SERVICE LETTER NUMBER 173
10000 BULKHEAD 7 STIFFENER ADDITION

By: RCG	Aircraft Makes/Model(s): AT-802 AT-802A	Float Model(s): 10000A	Note(s): Mandatory Compliance Service Letter P/N 1009163 ECO 24821
Approved: JRS			
Date: 8/16/2017			
Rev: A

This service letter applies to: Air Tractor models AT802 and AT802A with Wipline 10000A Fireboss Amphibious Floats S/N 10172 and prior installed per STC SA01795CH

Example of cracking in bulkhead 7. The damage is not limited to the area shown. Thoroughly check all of bulkhead 7.

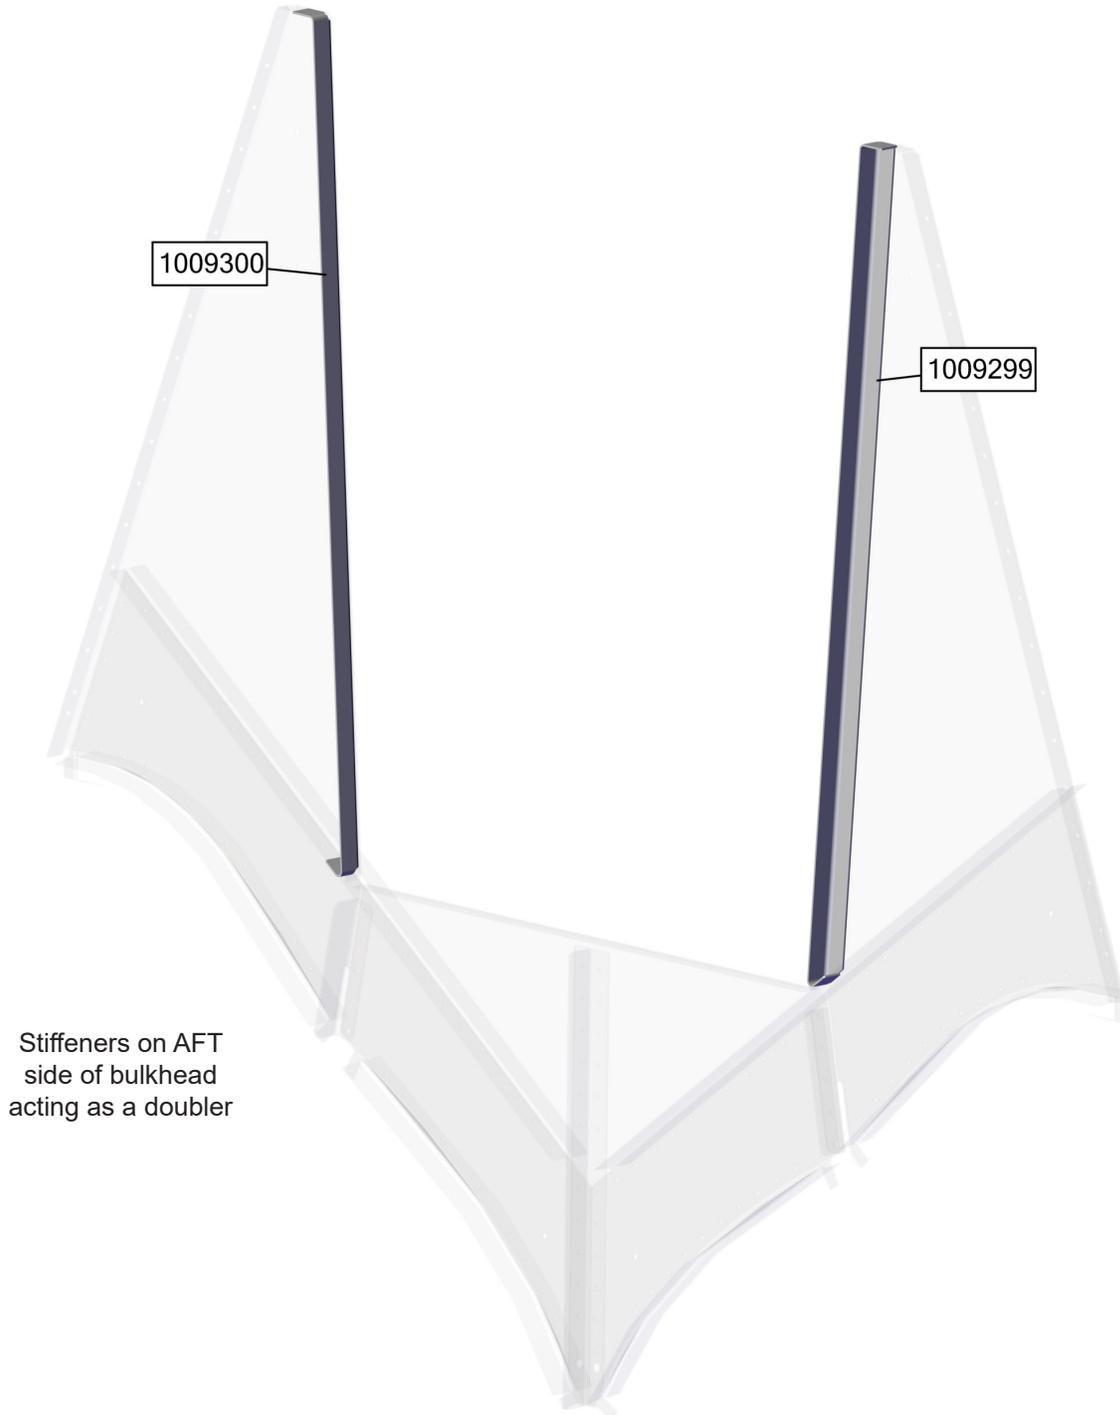
2. Inspect bulkhead 7 for cracking

3. If cracking is found in bulkhead 7, perform **method A** for repair. If no cracking is found in bulkhead 7, perform **method B** to prevent cracking

METHOD A

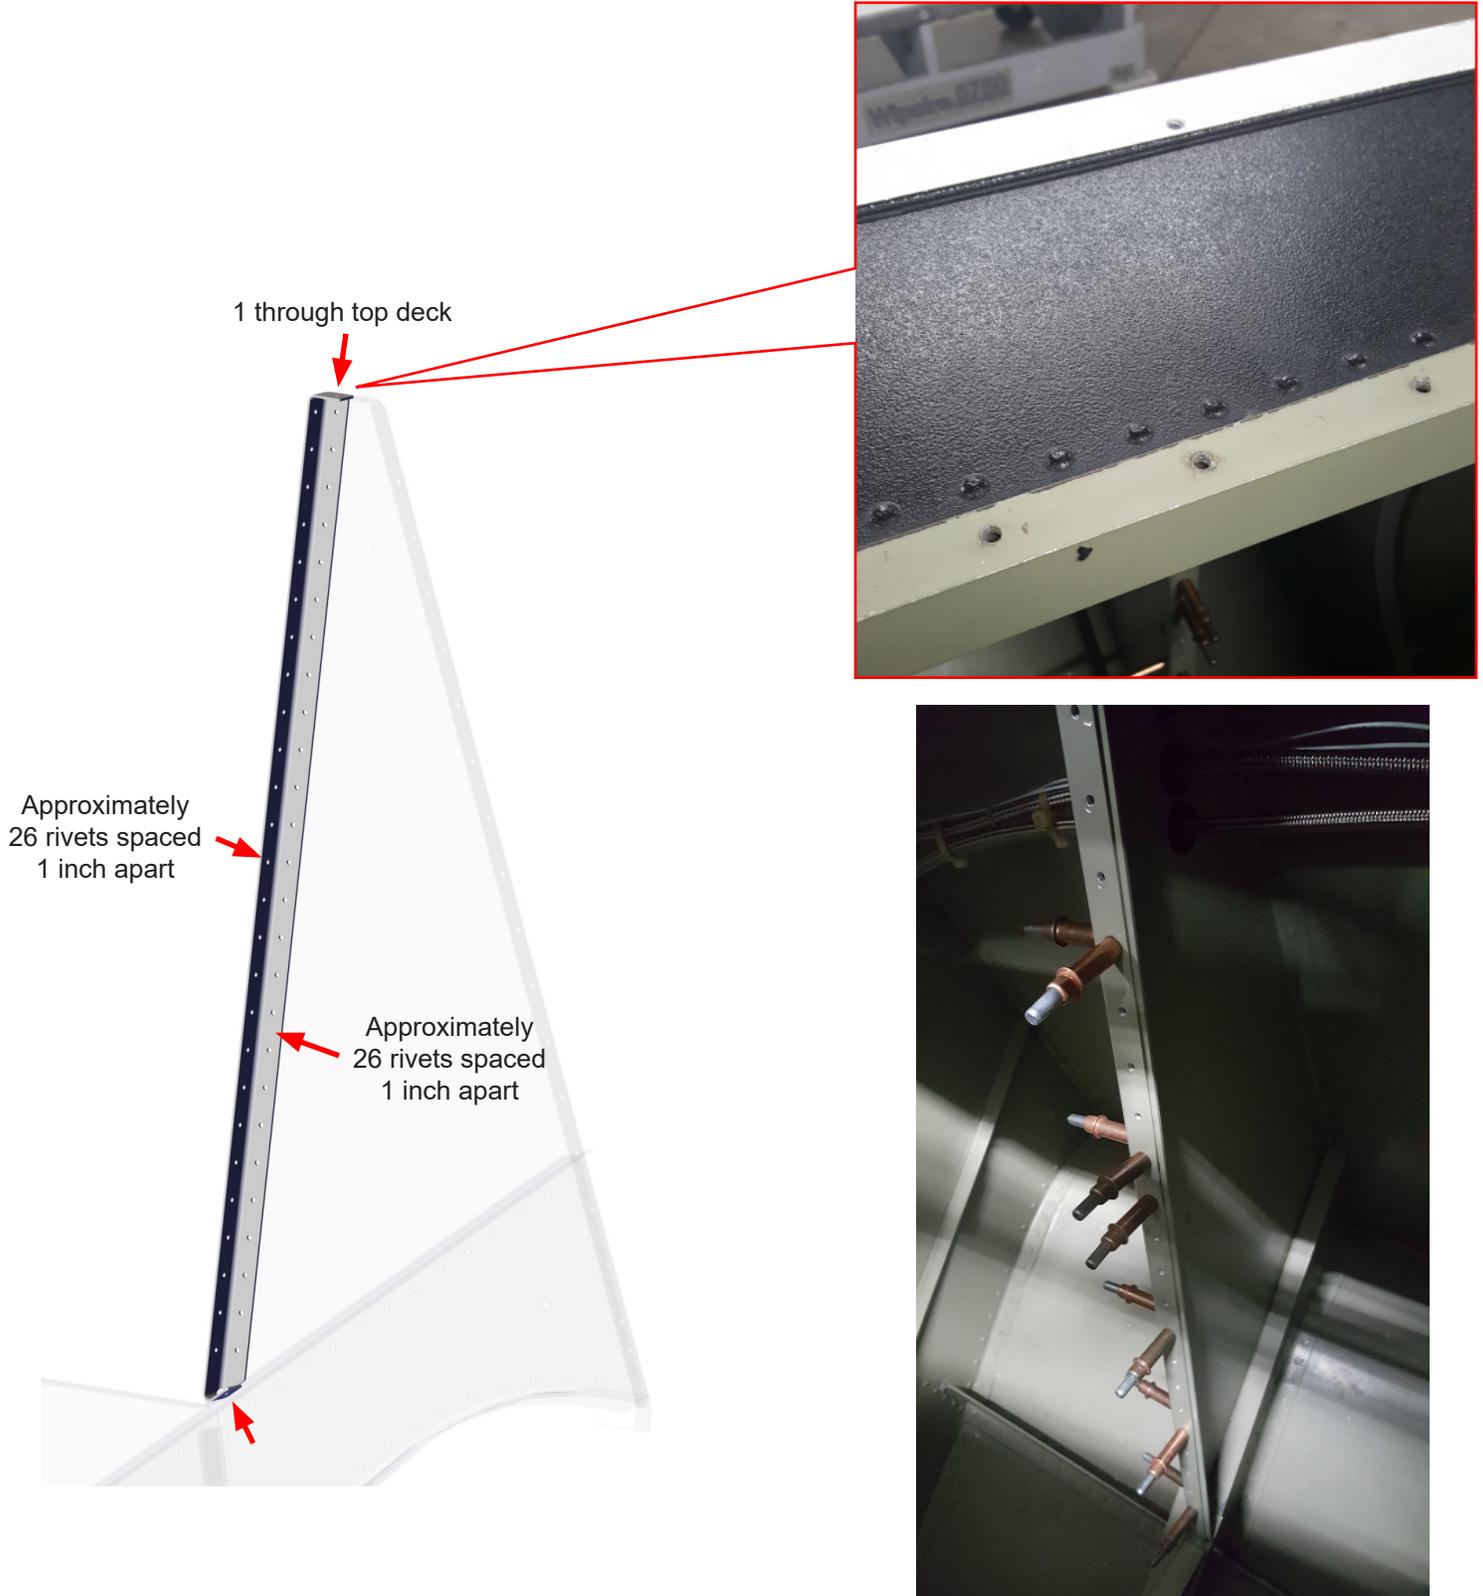
Perform method A if bulkhead 7 has cracks

1. Place left and right stiffeners on AFT side of bulkhead as shown

2. Match drill stiffeners to bulkhead 7 and cleco into place as shown

3. Rivet stiffeners in place as shown

METHOD B

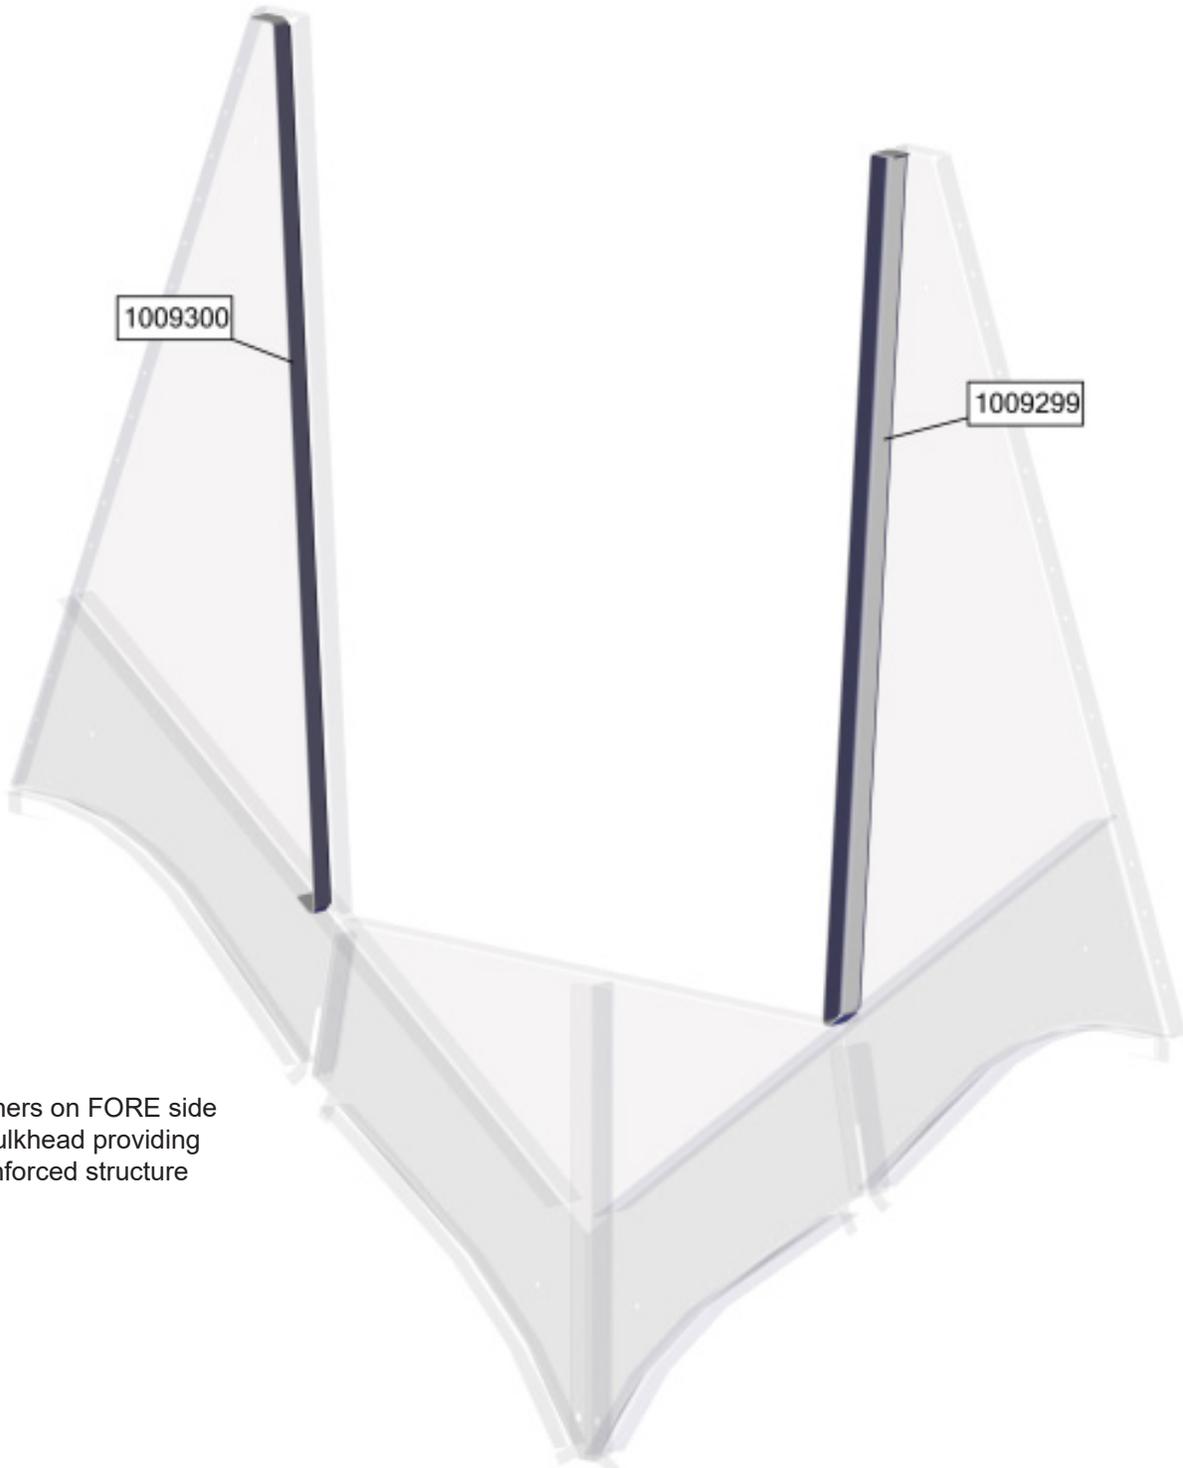
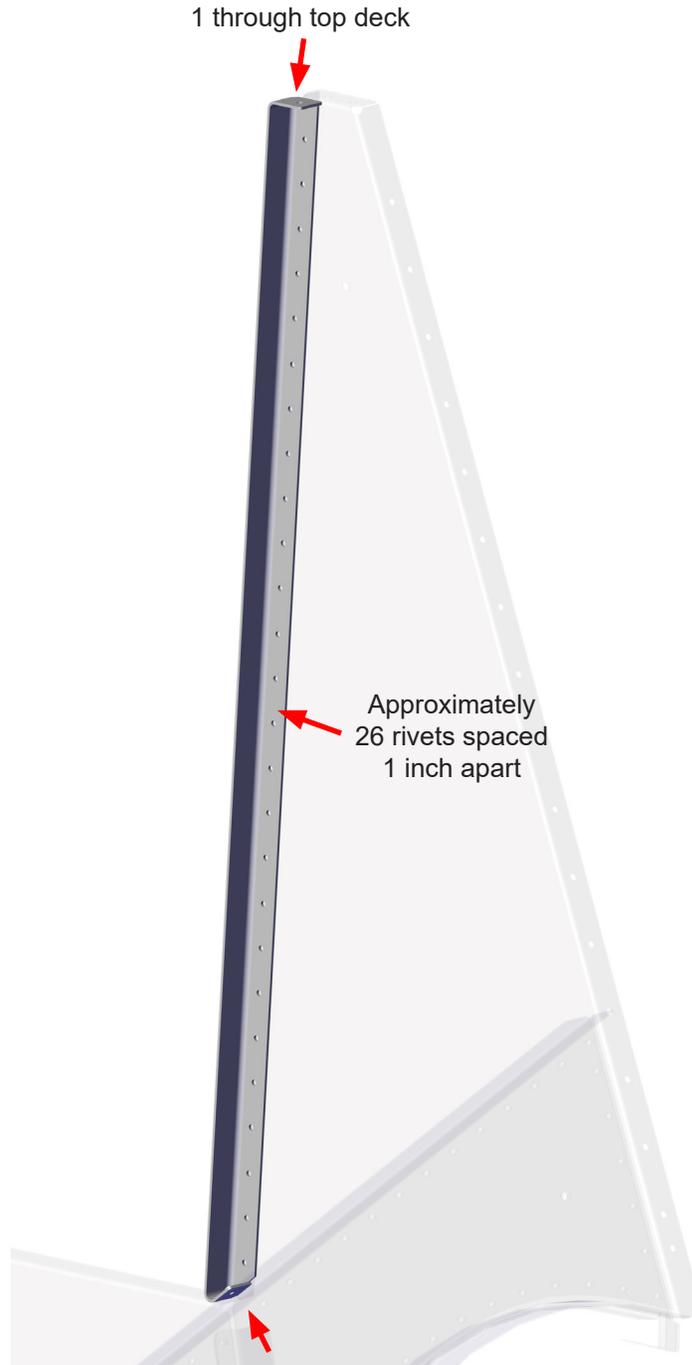
Perform method B if bulkhead 7 has no cracks

1. Place left and right stiffeners on FORE side of bulkhead as shown

Stiffeners on FORE side
of bulkhead providing
reinforced structure

2. Match drill stiffeners to bulkhead 7 and cleco into place

3. Rivet stiffeners in place as shown
